# City of Cambridge

**RE:** File No. 6860 –Stormwater Quality Sampling Stations & Scada Expansion Project-  
Addendum No. 3

The following questions were submitted and answered including 2 attachments.

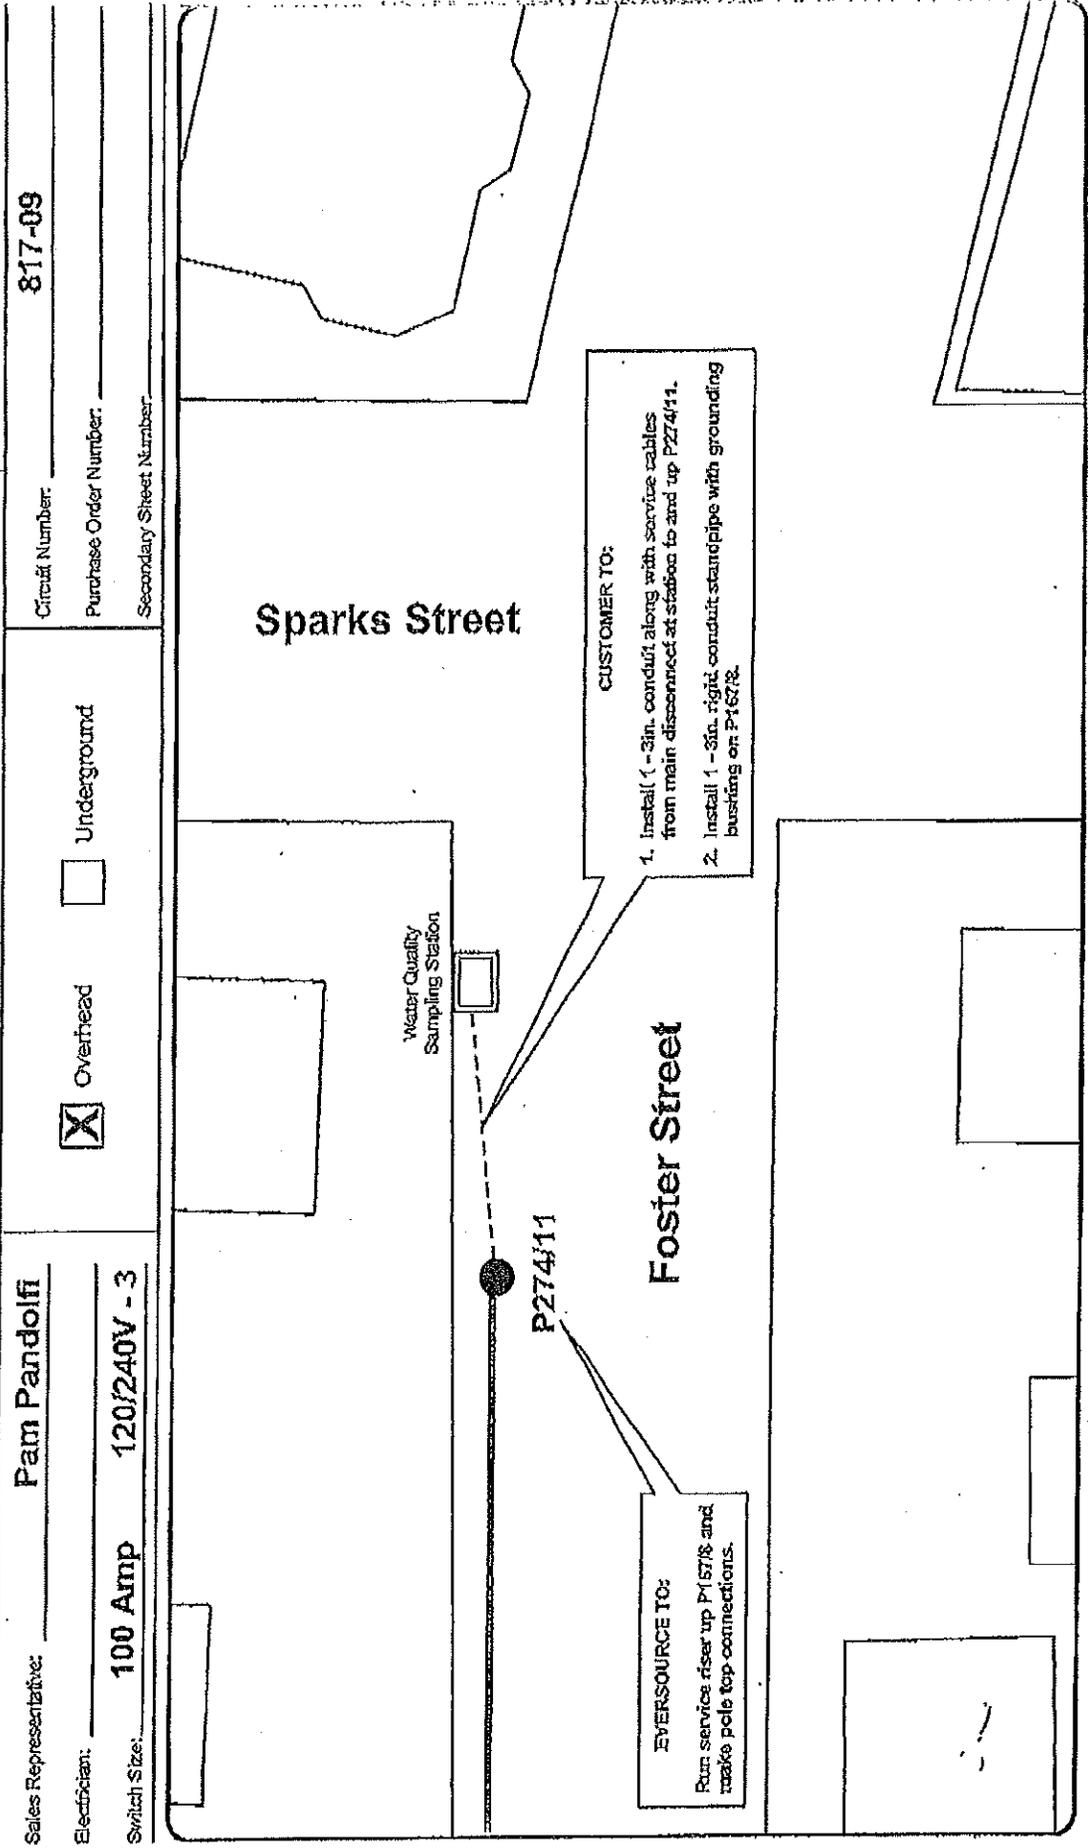
**Q10. Eversource (previously Nstar) will not have any costs for construction until work orders are applied for, they assign an Eversource Engineer and a site meeting is arranged.**

**A10. The City has obtained Eversource work orders and had reviews conducted for each site by their Engineer. See attached work order forms where conduit is to be installed, and reference the following work order numbers and fees that will be assessed for each site. (Please note that the CambridgePark Dr location is fed by the Cambridge Electric grid and does not require a permit or fee to activate the electrical service. )**

- a. Western Ave #2065709 Fee=\$2,881.00**
- b. Sparks St #2065717 Fee=\$0.00**

**EVERSOURCE TO:**  
Run service riser up P1578 and make pole top connections.

**CUSTOMER TO:**  
1. Install 1 - 3in. conduit along with service cables from main disconnect at station to and up P27411.  
2. Install 1 - 3in. rigid conduit standpipe with grounding bushing on P1578.
